September 29, 2020

RE: **Lot 16 Block 9 Unit 18**  
**Volcano Cliffs SAD 228**  
**6620 Canavio Rd. NW**  
**Grading and Drainage Plan**  
**Engineers Stamp Date 5/12/2020 (D10D003I16)**  
**Pad Certification Date: 8/24/2020**

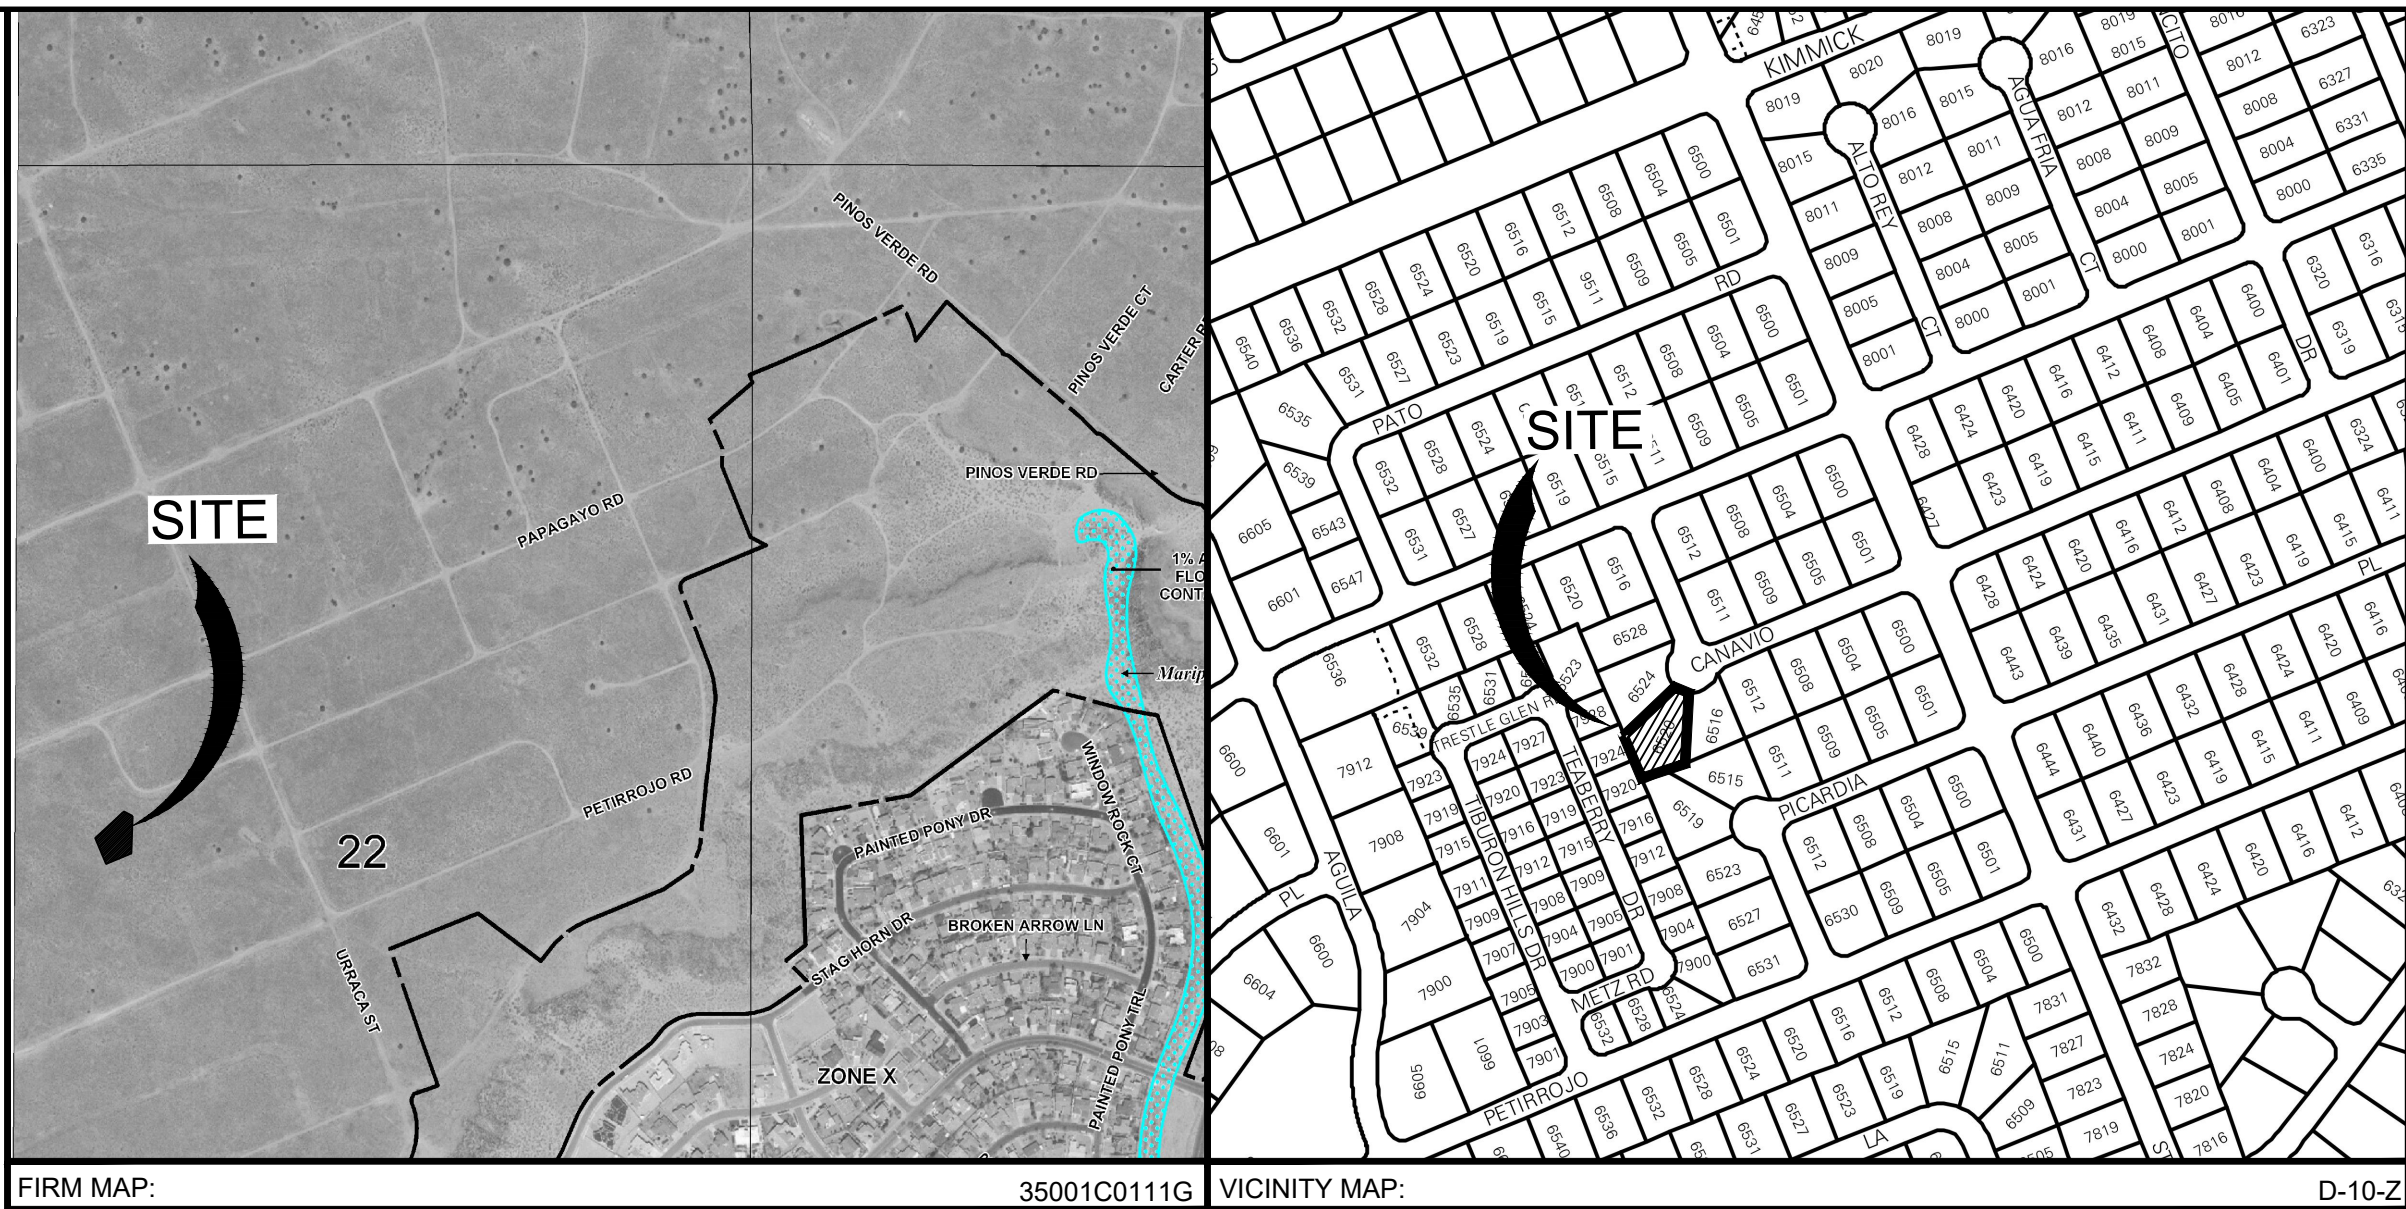
Based upon the information provided in your submittal received 9/25/2020, this plan is approved for Building Permit.

**Prior to Building permit approval a Pad Certification will be required, provided by the Engineer or a registered Land Surveyor.**

Reiterate to the Owner/Contractor that a separate permit for a garden/retaining wall must be obtained with the approved G&D plan and Pad Certification. **Also, if a swimming pool is to be added after this approval the grading and drainage plan will change and will need to be resubmitted.**

**Prior to Certificate of Occupancy release, Engineer Certification per the DPM checklist will be required.**
